<b>CITY OF WESTMINSTER</b>			
<b>PLANNING APPLICATIONS COMMITTEE</b>	<b>Date</b> 24 January 2017	<b>Classification</b> For General Release	
<b>Report of</b> Director of Planning		<b>Ward(s) involved</b> Knightsbridge And Belgravia	
<b>Subject of Report</b>	45 Chester Square, London, SW1W 9EA,		
<b>Proposal</b>	Variation of Conditions 1 and 6 of planning permission and condition 1 of listed building consent both dated 15 December 2011 (RNs: 11/07657/FULL and 11/07659/LBC) for demolition and rebuild of 44 Ebury Mews to provide a self-contained residential unit at ground and first floor level, formation of new basement beneath mews building to provide additional residential accommodation in connection with the main house at 45 Chester Square, construction of a four storey lift shaft extension to the rear of 45 Chester Square, installation of mechanical plant within the front basement vaults with associated louvred doors, infill extension to rear lightwell, rebuilding of part rear facade associated internal alterations to 45 Chester Square. Namely, provision of roof terrace with railings on part of the roof of 44 - 45 Ebury Mews with access via doors in rear elevation of 45 Chester Squ

PROPOSED SECTION A

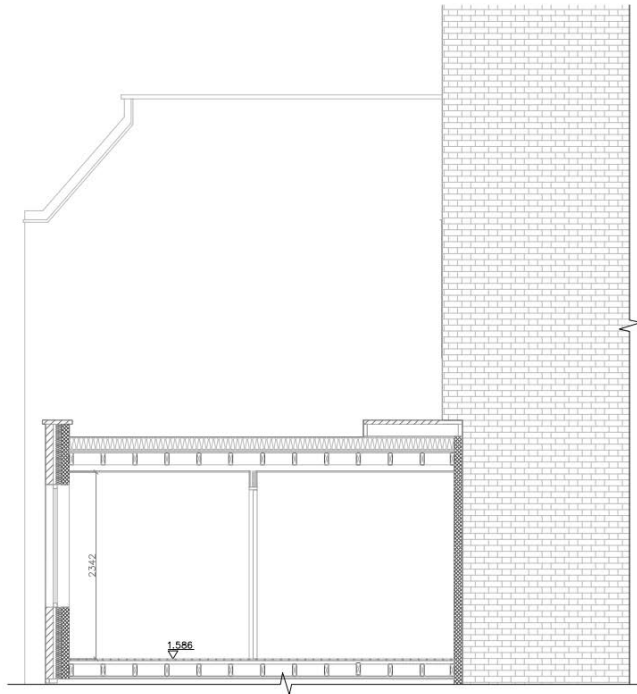
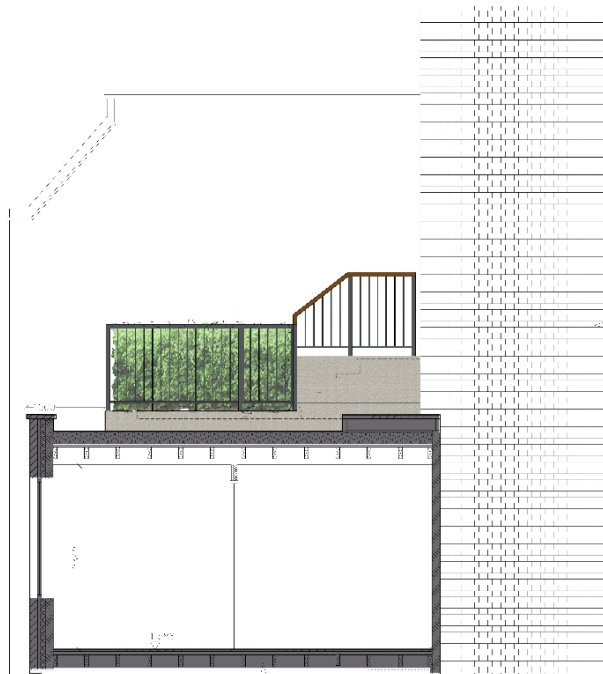
- 15 The planting show on Proposed Section A and Proposed Second Floor Plan must be set back behind on the internal side of the railing and maintained to be below the height of the railings.

- 11 The planting shown on Proposed Section A and Proposed Second Floor Plan must be set back behind on the internal side of the railing and maintained to be below the height of the railings.
